Date November 21, 2011

## **STAFF REPORT**

Franklin Field Senior Apartments PUD - 5300 Franklin Avenue

# CONCEPTUAL PLAN: FRANKLIN FIELD SENIOR APARTMENTS

PUD  
 2

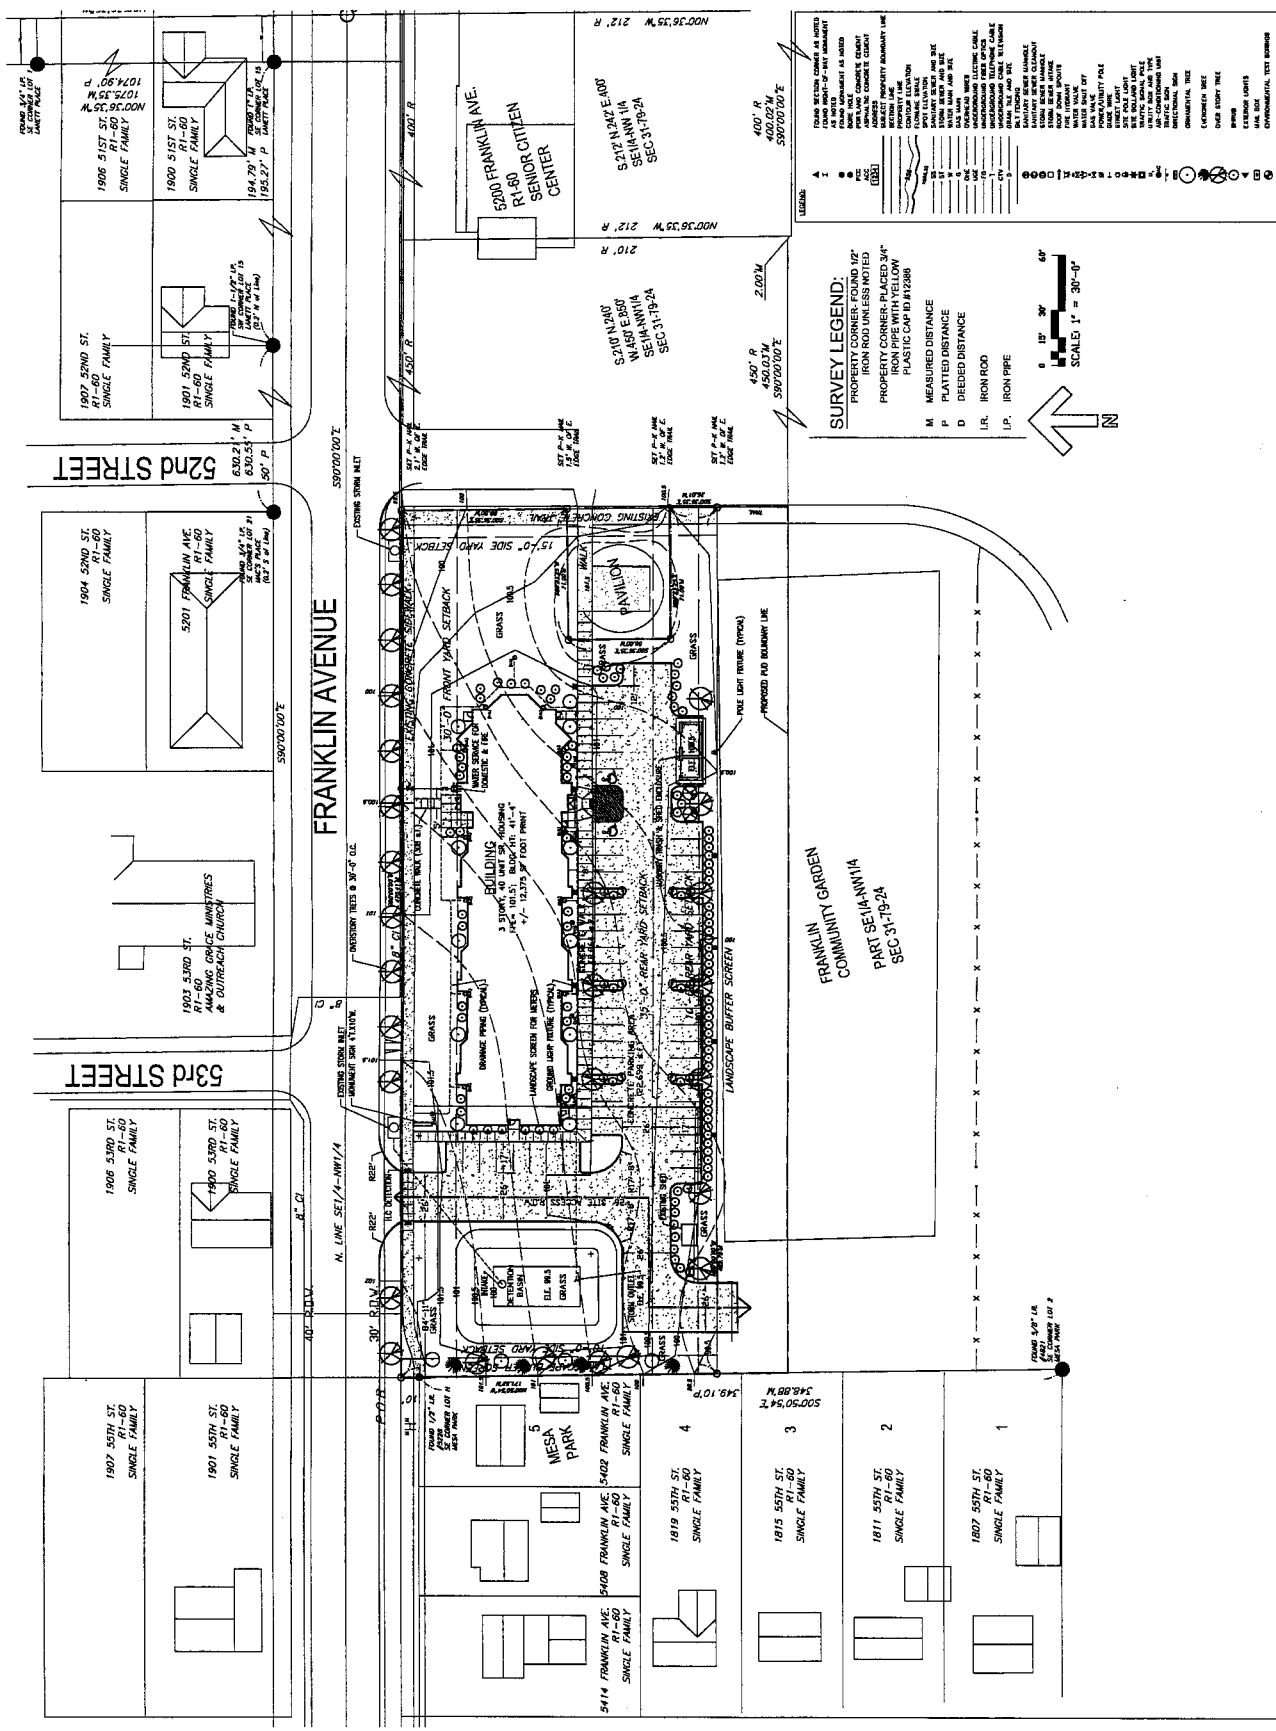
15. Revision of the plan view sheet to incorporate a screen fence along the western boundary.
16. Revision of the architectural elevations to show screening of meters on the west elevations.

There are overstory trees proposed spaced approximately 50 feet on center along the northern edge of the property. Normally these would be sought by staff as street tree plantings with some being perimeter lot plan plantings between proposed parking lot and the street. However, in this instance the water main is directly below the area where they would be planted as street trees along the east half of the property. Staff

While pedestrian connections are proposed north and east of the building to the trail, community center and public sidewalk along Franklin Avenue, there is not a connection west of the building. Internal sidewalk west of the building accesses proposed parking there, but does not show a complete connection to the public sidewalk in Franklin Avenue. Staff recommends that the Conceptual Plan be revised to connect the western sidewalk to the public sidewalk along Franklin Avenue.

Additionally the Conceptual Plan does not have narrative to reflect bulk standards. The Plan view shows a 30-foot building setback on the north, a 35-foot setback on the south, a 15-foot setback on the east, and a 10-foot setback on the west. Staff believes that the principle building setback should be established at 30 feet along the entire perimeter of the PUD with minimum setbacks for paving and accessory structures of 30-foot on the north and 10-foot along the east, west and south boundaries with exclusion for the maneuvering turnaround for fire apparatus and access for Parks maintenance vehicles.

PROJECT NO.	111727.00
DATE	11/11/11
DRAWING NO.	111727.00
SHEET NO.	
TITLE	
EXTERIOR	
SCALE	
PUD	3

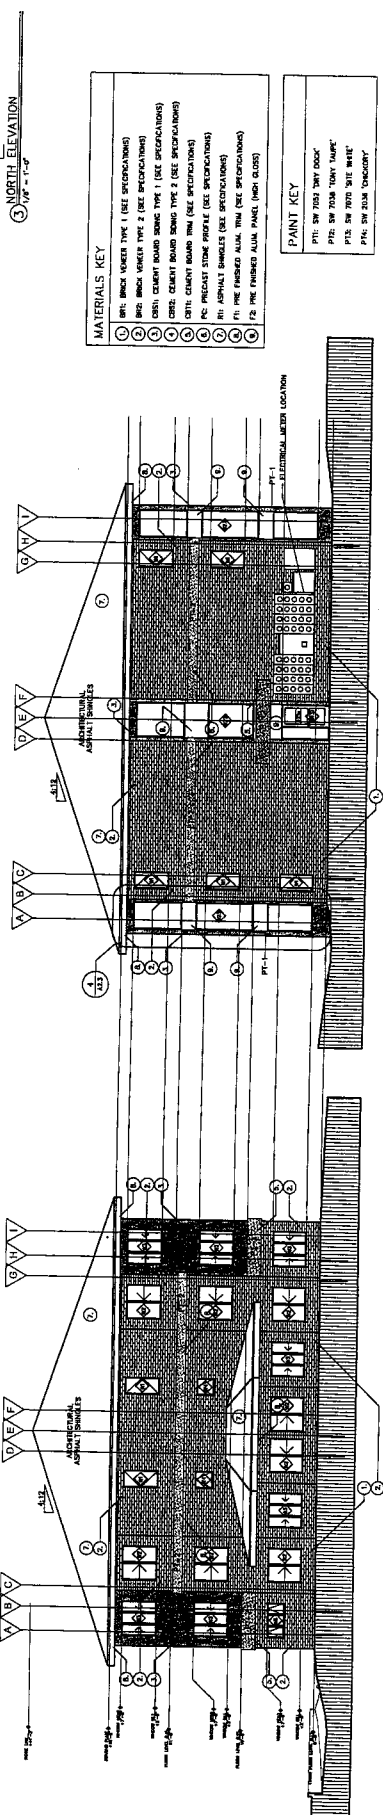
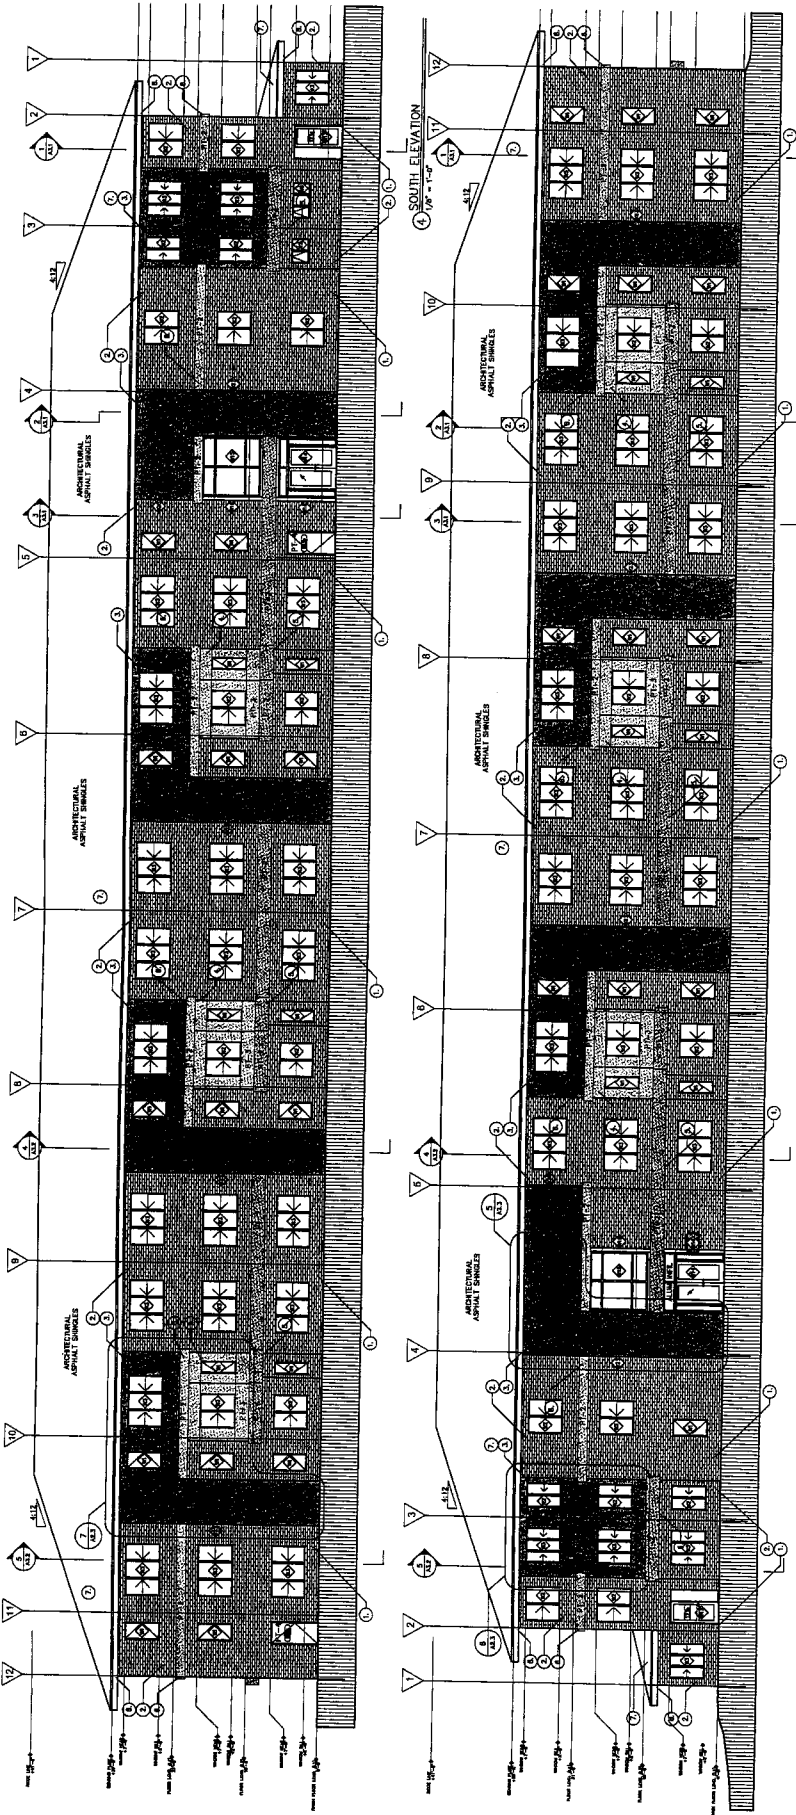
The Plan does not include screening of utility meters on the west facade and any other mechanical equipment that may be as part of the project. Staff recommends that the narrative and elevations be revised to incorporate screening. The detail elevations also need to be revised to show screen fencing and lighting typicals. The proposed monument sign is not supported by any minimum standards for signage allowance. The PUD standards narrative should include minimum standards to accommodate this signage.
